COMMUNITY
connectivity program

Town Village District, Route 14 – Road Safety Audit

May 9th, 2016

Figure 3. Scotland Town Village Center Road Geometrics

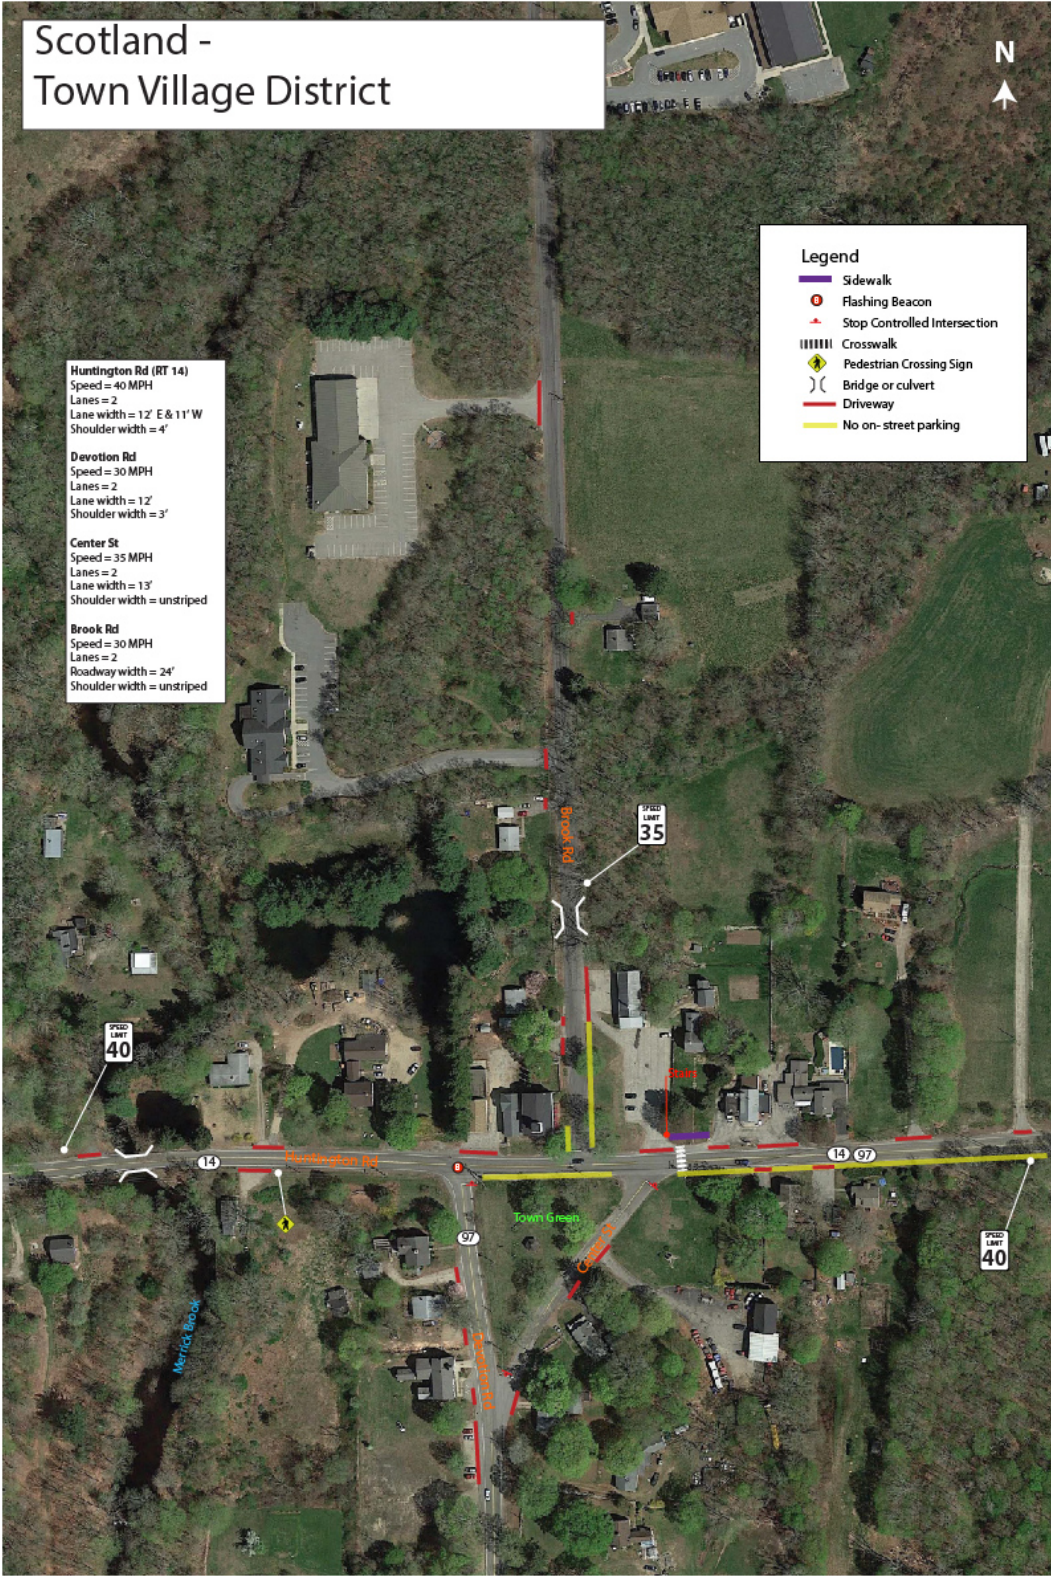
Figure 3 and Table 3 summarize the roadway geometrics in the study area.

Figure 17. Long Term Recommendations

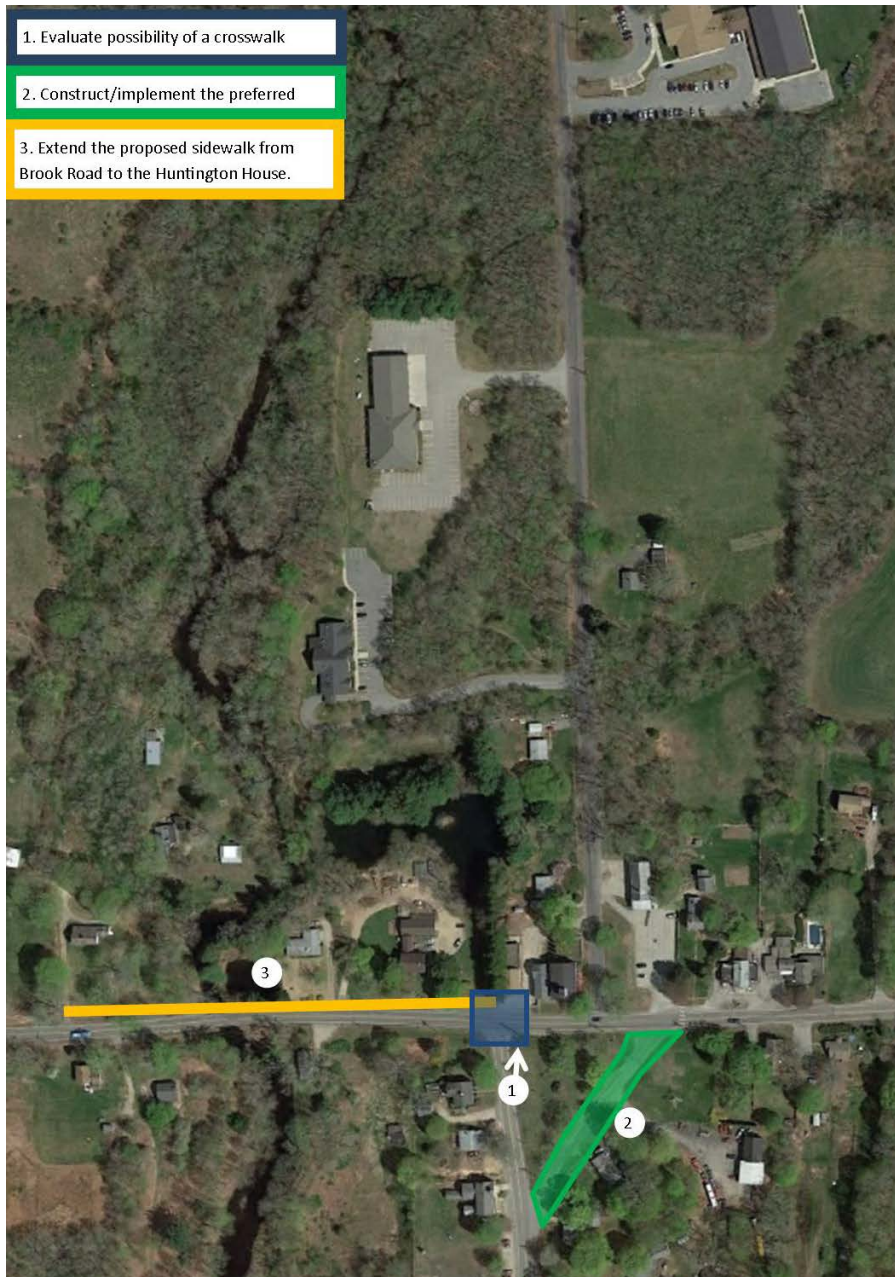
1. Evaluate the impacts of providing a new crosswalk at the intersection of Huntington Road/Devotion Road. This will include evaluation of a new signal.
2. Construct/implement the preferred redesign of Center Street (see Medium Term Measures).
3. Extend the proposed sidewalk from Brook Road to the Huntington House.
